Access Compliance Report

Public Rights-of-Way

| Intersection ID: 5992 | Main Street: GIBBON_RD | Cross Street: GRENELEFE_VILLAGE_RD | Location: SW |
| ADA ID: 9402CB0B734D | Ramp Type: Perp | Initial Pass/Fail: Fail | Overall Compliance: No |

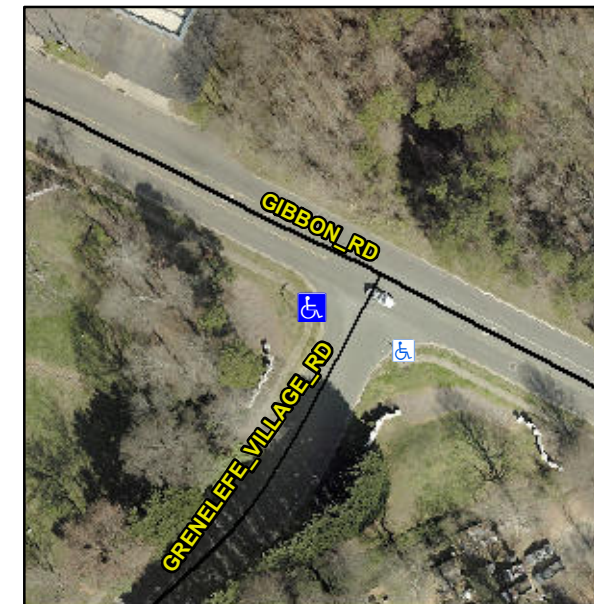
Not Found, R304.5.1, R304.2.2, R304.5.3

| Compliance | Description | Data | Compliance | Description | Data |
|------------|-----------------------|-------|------------|-----------------------------|------|
| N/A | Ramp Length (in) | 46.0 | No | Ramp Slope (%) | 8.5 |
| No | Ramp Width (in) | 47.0 | No | Ramp XSlope (%) | 2.3 |

Remove & Replace Entire Ramp.
